KINGSTON STEAM PLANT - ANNUAL ASH DISPOSAL AREA INSPECTION

SUBJECT: INTERIM DISPOSAL AREA INSPECTION

Plant: Kingston Steam Plant Area: Ash Disposal Area

Vegetative growth
on dike slopes

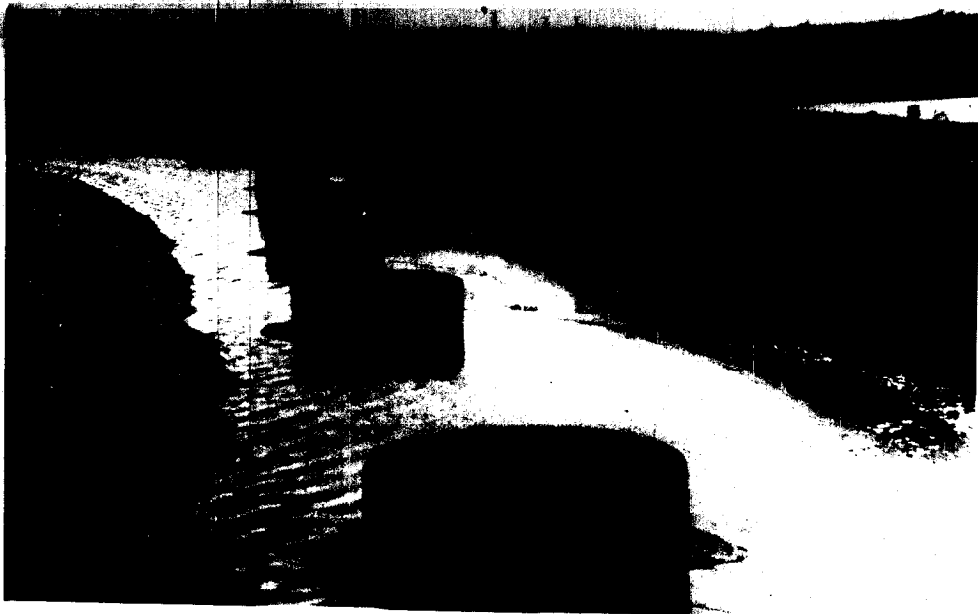
All dikes appear to be stable. The tops of all dikes are smooth and close
to the grade with a good crushed stone surface. A good vegetative cover
exists on the outside slope (picture 1) in most areas (see accompanying
dike shapes were free of any excessive erosion.

Fertilize and resod all areas of the dike slopes where an adequate vegetative cover has not been established, with type C, mixture E, in accordance with sections 182 and 183 of the T-1 Specifications.
